Flight Procedures Cover Page	Task Action: FLIGHT CHECK	Task Type: IAP	Estimated Chart Date: 8/7/2025	APWS Task ID: 1CA084BC55834C34A9480B2163331563	APWS Project ID: C3AB594EDD314931B79E6977F237B91E
Procedure: RNAV (GPS) Y RWY 16R AMDT 2		Enroute: NO	Specialist: Hardison, Dustin		Agreement Number:
Airport ID: KDEN			Airport City: DENVER		State: CO
Facility ID:	Facility Type:	Flight Inspection Remark Type: New FC Slot			
Procedure Comments: Second Intermediate segment starting at CLFFF added to permit STAR use and downwind entry. Procedure developed using active airport data. Contact Rake McGraw AJV-A422 (405)597-8711 QUALITY 26 CHECKED QUALITY 38 CHECKED

FIPC BASIC FORM							
PROCEDURE: RNAV (GPS) Y RWY 16R AMDT 2			AIRPORT NAME: DENVER INTL		AIRPORT ID: KDEN	SPECIAL CONTROL NO: OG-04-201-25	
FAC ID: KDEN16R.02Y		CITY: DENVER			ST: CO	ORIG CHART DATE: 10/02/2025	
DFL TYPE: PROC/S	THIRD PARTY: ☐ YES	EST. TIME ON SITE: 0.4	REIMB. NUMBER:		PTS TASK ID: 1CA084BC55834C34A9480B2163331563		
PREFLIGHT NOTES							
REVIEWER:					DATE:		
COMMENTS:					CHECK ONE:		
					☐ FLT CK REQ ☐ NFCR ☐ REJECT		
							YES
					CPV COMPLETE?		X
PROCEDURE RESULTS							
INSPECTION DATE: 03/25/2025		CREW

RNAV (GPS) Y RWY 16R
DENVER INTL (DEN)

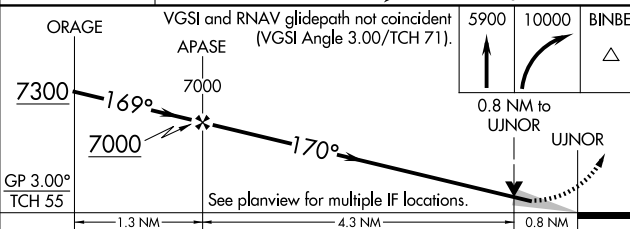
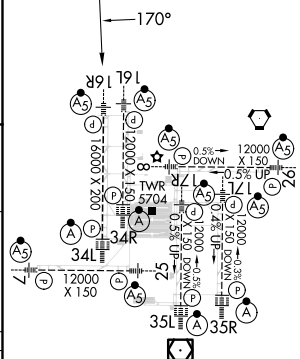
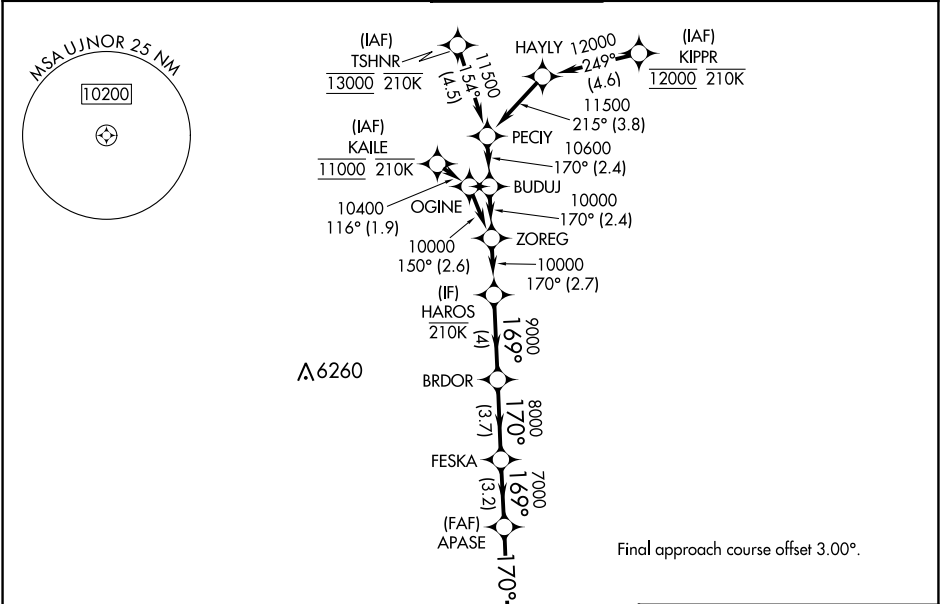
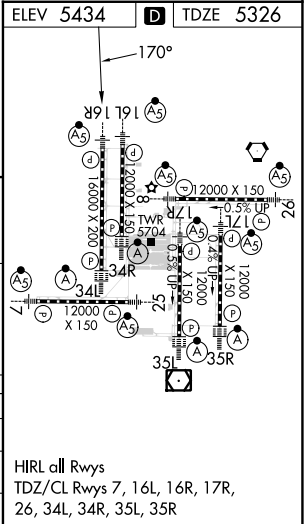
FIPC BASIC FORM						
PROCEDURE: RNAV (GPS) Y RWY 16R AMDT 2			AIRPORT NAME: DENVER INTL		AIRPORT ID: KDEN	SPECIAL CONTROL NO: SG-12-052-24
FAC ID: KDEN16R.02Y		CITY: DENVER			ST: CO	ORIG CHART DATE: 02/20/2025
DFL TYPE: PROC/S	THIRD PARTY: ☐ YES	EST. TIME ON SITE: 0.4	REIMB. NUMBER:	PTS TASK ID: 1CA084BC55834C34A9480B2163331563		
PREFLIGHT NOTES						
REVIEWER: joel p murphy					DATE: 02/05/2025	
COMMENTS:					CHECK ONE:	
					☒ FLT CK REQ ☐ NFCR ☐ REJECT	
						YES
					CPV COMPLETE?	
					X	
PROCEDURE RESULTS						
INSPECTION DATE: 02/05/2025	CREW #: VN451	N #: N87	INSTRUMENT PROCEDURE STATUS:		ARINC CODING:	
			☐ SAT ☐ SAT W/CHANGES ☒ UNSAT		☒ SAT ☐ SAT/GOLD ☐ UNSAT	
FLIGHT INSPECTOR SIGNATURE:			PRINTED NAME:			NOTAM INITIATED?
joel p murphy @ 02/05/2025 16:14			MURPHY, JOEL PATRICK			☐ YES ☒ NO
FLIGHT INSPECTOR REMARKS: Procedure flew SAT. UnSAT for human factors. The procedure is very cluttered and hard to distinguish what the proper fix, altitude, and speed restriction should be flown around FESKA.
